**BEFORE THE OFFICE OF ENERGY INFRASTRUCTURE SAFETY
OF THE STATE OF CALIFORNIA**

**COMMENTS OF THE GREEN POWER INSTITUTE ON THE
2023-2025 BASE WILDFIRE MITIGATION PLANS OF THE SMJUs**

June 29, 2023

Figure 1. PG&E HFTD Tier 2 risk events during RFW, HWW, and normal (none) days from 2020-2022

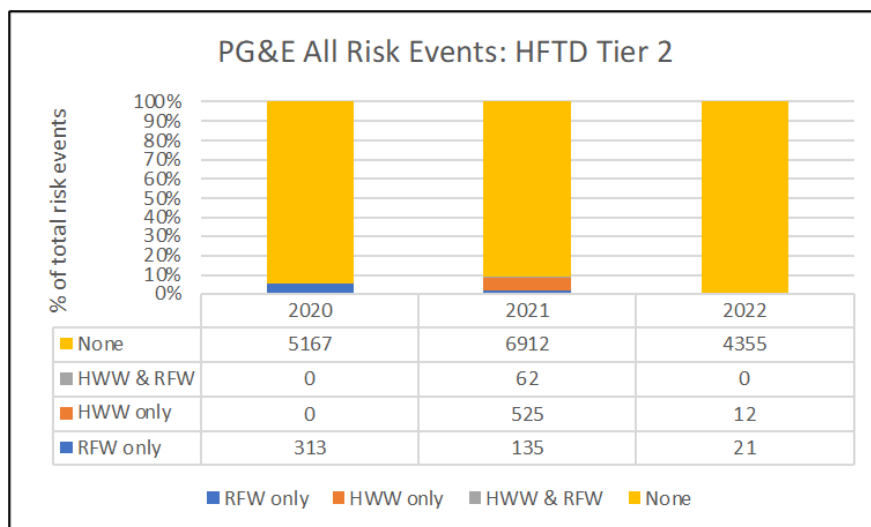
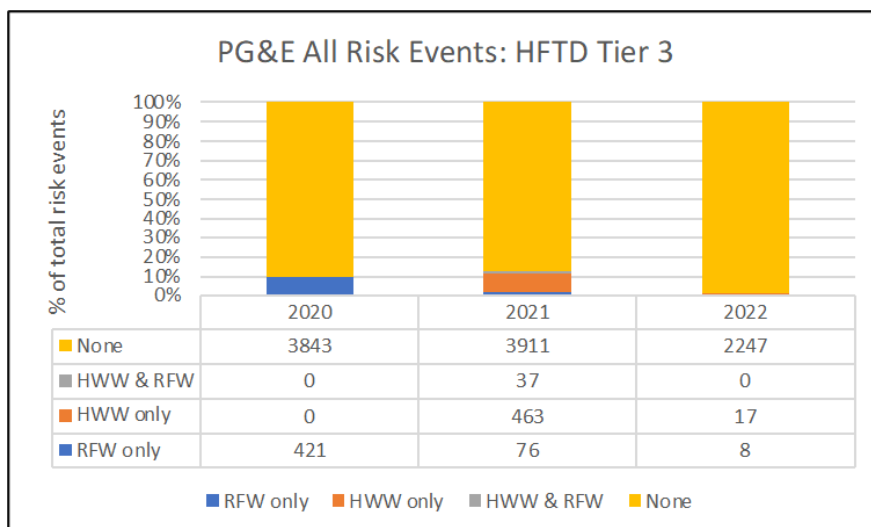
therefore increased likelihood of ignition do not constitute the majority of outage events, which occur under “normal” wind conditions. PG&E has the largest risk-event dataset, and therefore illustrates this point clearly (Figure 1 and 2). This evokes many risk-modeling, and therefore mitigation selection questions, especially whether risk modeling should treat P(i|f) and wildfire consequence as dependent or independent variables, and how fuel versus wind-driven fires should be considered in risk modeling and model application.
